**STAFF RECOMMENDATION AND REQUEST FOR PUBLIC HEARING TO INFORM THE  
FINAL AGENCY DECISION - WAVE DISSIPATION SYSTEM**

**December 8, 2016**

**Figure 2:** Scarp erosion landward of the Beachwood East WDS during storm conditions before the placement of emergency sandbags. This was approximately 1 month after the WDS was installed.

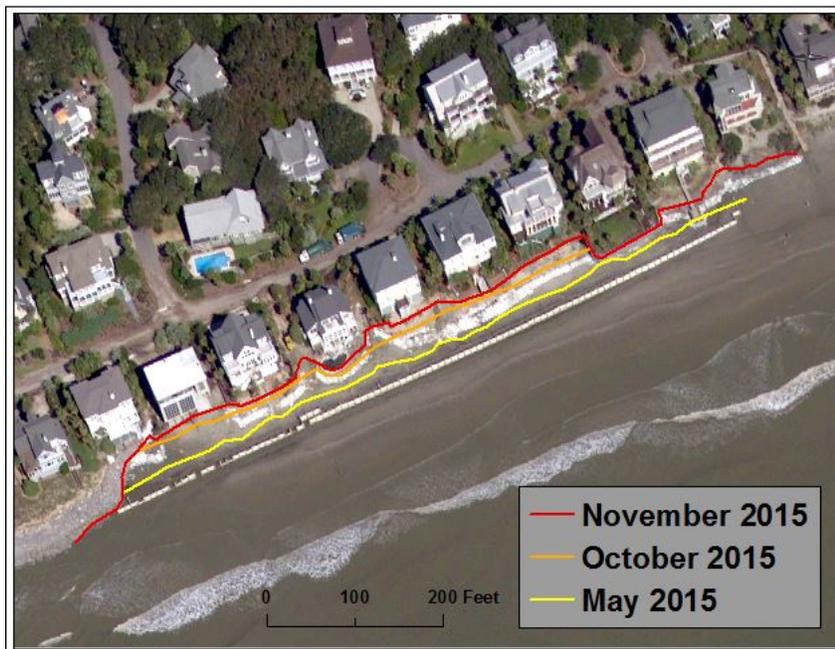
- The WDS did not maintain the scarp line or MHW positions. While the scarp line position did not change drastically during GEL’s study, which covered the time period between March and July 2016, the scarp eroded significantly at each WDS site after the structures were installed, but before GEL began their study (Figure 2). This earlier scarp line movement was documented in the data collected by The Citadel and mapped by DHEC – OCRM (Maps 1 and 2). This continued scarp erosion led to property owners requesting emergency sandbags for scarp protection at different times during the study at all four WDS locations. The sandbags at Harbor Island were already present prior to installation of the WDS at that location, but several renewals of the sandbag Emergency Orders were issued by DHEC-OCRM during the study to allow property owners to continue to protect their property from erosion (Figure 3). At Beachwood East, sandbags have been on the beach landward of the WDS since Fall of 2015 (Figure 4). At Ocean Club Villas, the sandbags were cut open after the broken slab beneath the building was repaired to allow the sand to be added landward of the WDS (Figure 5). The sandbags were subsequently removed from the site. At Seascape Villas, the sandbags were also cut open to allow the sand to be added landward of the WDS. The sandbags were cut open and removed after the second tier of the WDS was installed (Figure 6).

**Figure 14:** Scour (trenching) on the seaward and landward sides of the Beachwood East WDS.

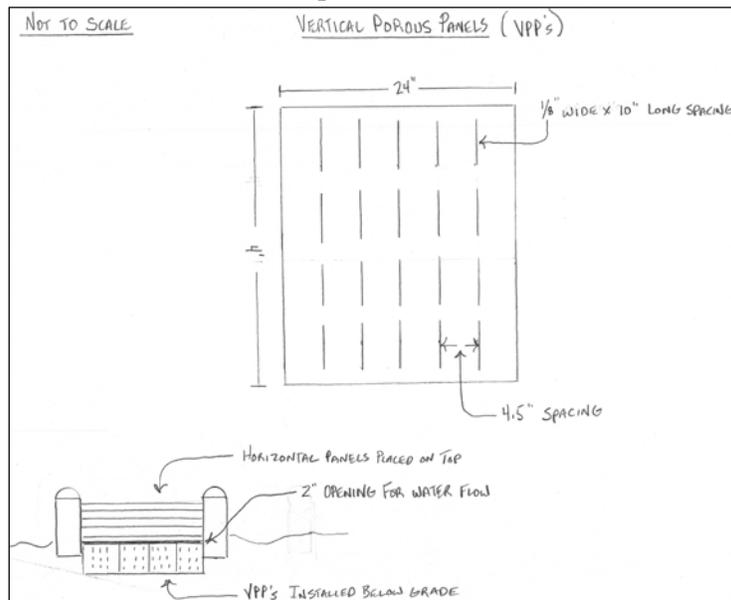
- DHEC – OCRM staff observed persistent trenching and scour at the base of the structures at all sites except Seascape Villas (Figures 14 and 15).
- Trenching and scour was photo documented at the following locations and dates.
  - Ocean Club in April and May of 2016.
  - Beachwood East in September, October, November, and December 2015 and February, April, May, and June 2016.
  - Harbor Island in July, August, September, October 2015, and March and April 2016.

**Figure 22:** Erosion at the northeastern end of the Beachwood East WDS (left) and the southwestern end of the Ocean Club WDS (right).

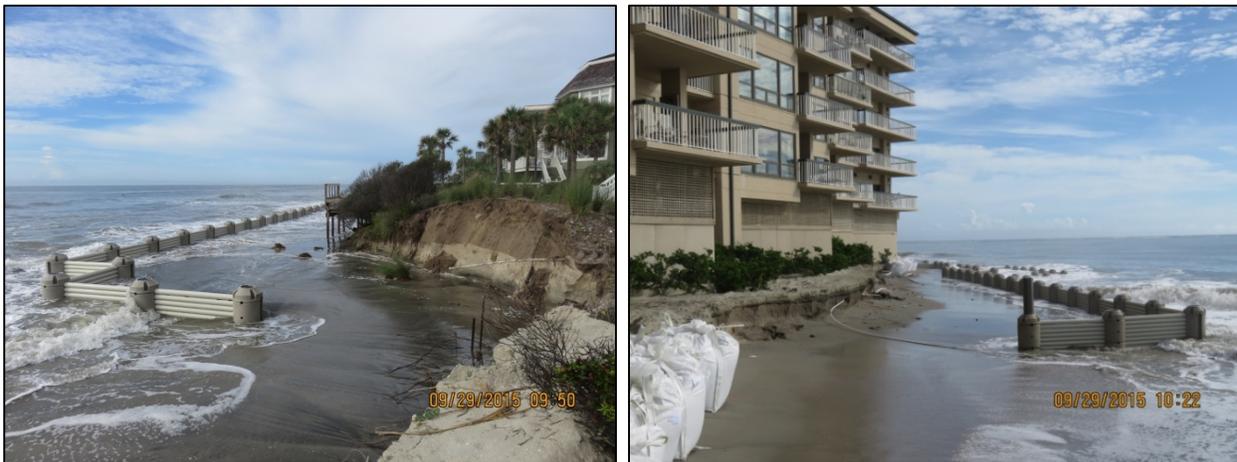
- Adjacent properties: The WDS does not prevent erosion of the shoreline on the “down-coast” side of the structure. In fact, where the WDS terminates, increased erosion was observed on unprotected properties immediately adjacent to the WDS (Figure 22).

- The WDS does not prevent erosion of the shoreline on the “down-coast” side of the structure. In fact, where the WDS terminates, increased erosion was observed on unprotected properties immediately adjacent to the WDS (Figure 22).
